HISTORIC AND DESIGN REVIEW COMMISSION

June 07, 2017

HDRC CASE NO: 2017-244
ADDRESS: 143 CEDAR ST
LEGAL DESCRIPTION: NCB 935 BLK B LOT S 43.8 FT OF E 100FT OF 9 & N 6.2FT OF E 100FT OF 10
ZONING: MF-33, H HS
CITY COUNCIL DIST.: 1
DISTRICT: King William Historic District
LANDMARK: Burda House
APPLICANT: Jim Poteet/Poteet Architects
OWNER: Dwight Hobart Patty Ortiz
TYPE OF WORK: Rehabilitation, foundation repair, window repair, roof repair, fencing, swimming pool installation, construction of a rear addition and Historic Tax Certification

ELEVATION: SOUTH

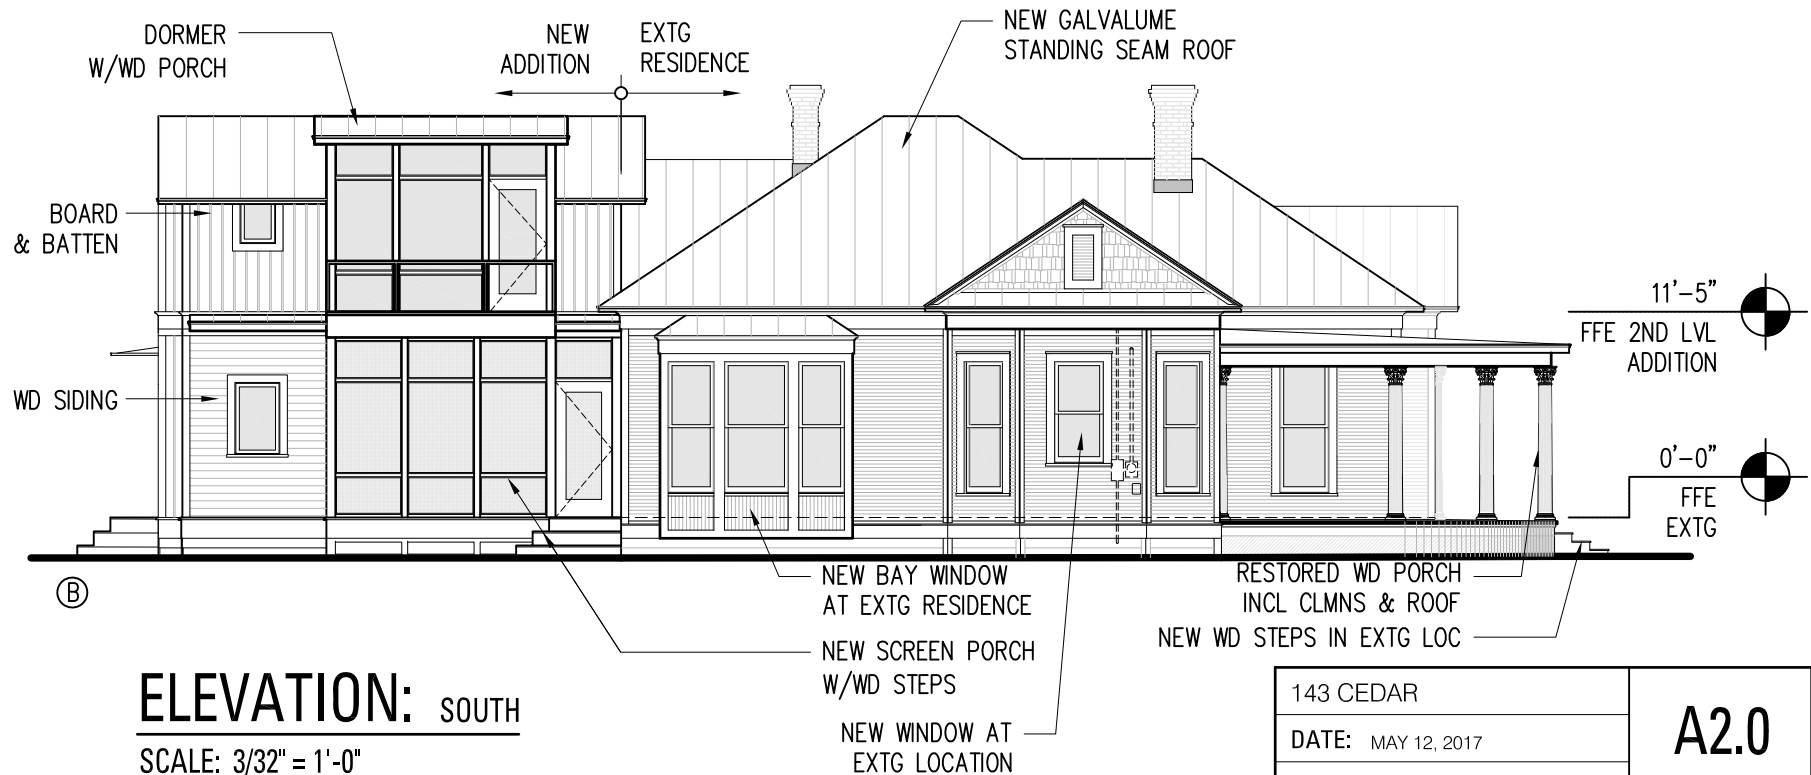
- c. SIDE WINDOW BAY – The applicant has proposed to construct a side window bay on the southern façade of the primary historic structure. The proposed side window bay is to be located to the rear of the original window bay. The proposed bay is to feature a massing and design that is subordinate to the two original window bays on the historic structure. The applicant has proposed window openings that are consistent with those on the primary historic structure. The applicant has proposed to detail this bay window differently than those that are original to the structure. Staff finds that the subordinate massing in addition to the difference in detailing that the proposed bay is appropriate.

ELEVATION: LINE OF SIGHT

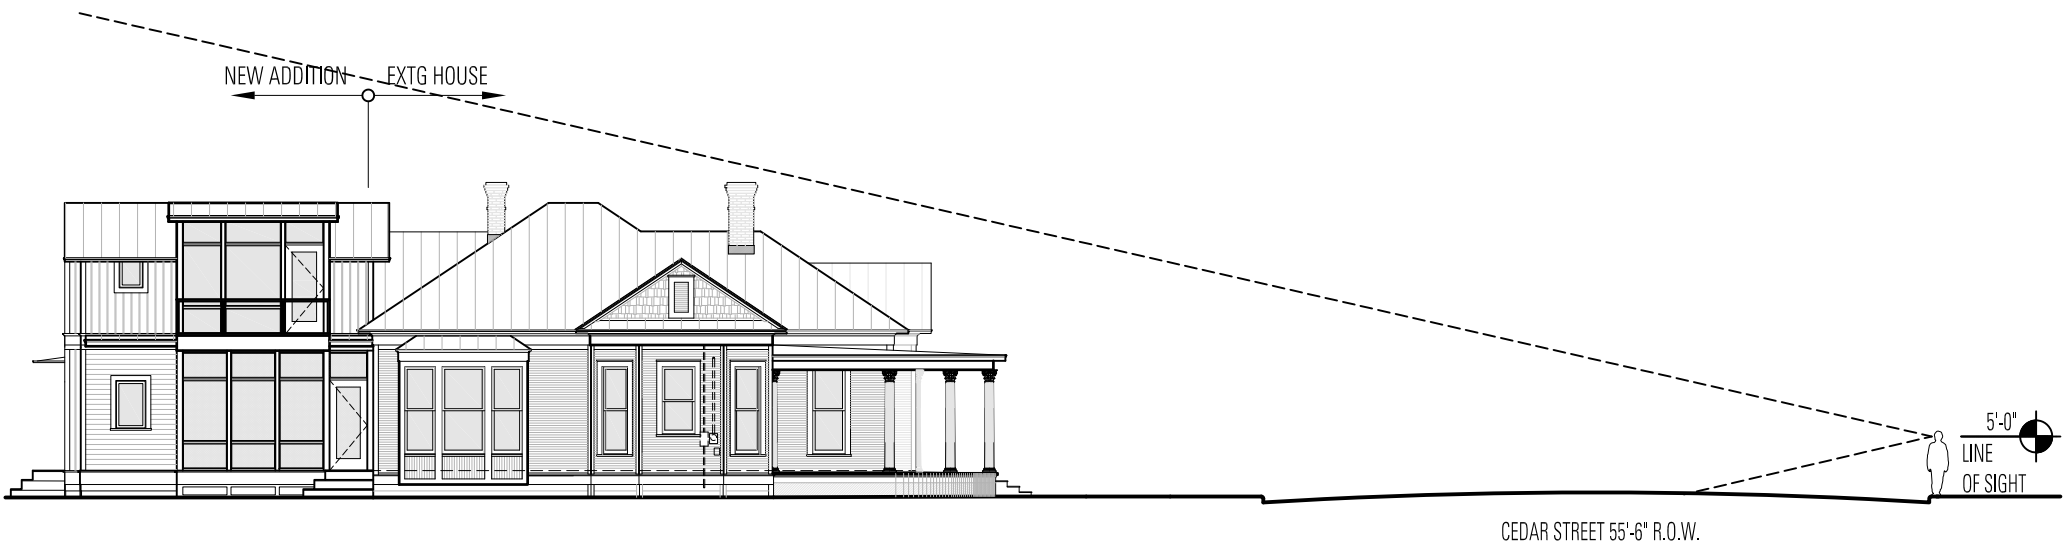
- e. SCALE, MASS AND FORM – Regarding scale, mass and form, the applicant has proposed for the addition to feature a roof height that is the same as that of the primary historic structure, a width that is subordinate to that of the primary historic structure and a footprint that is subordinate to that of the primary historic structure. Regarding height, the applicant has proposed an addition that features one and one half stories. Staff finds that the applicant should provide both a line of sight study and perspectives to ensure that the proposed rear addition will not feature

a massing that will dominate the primary historic structure.
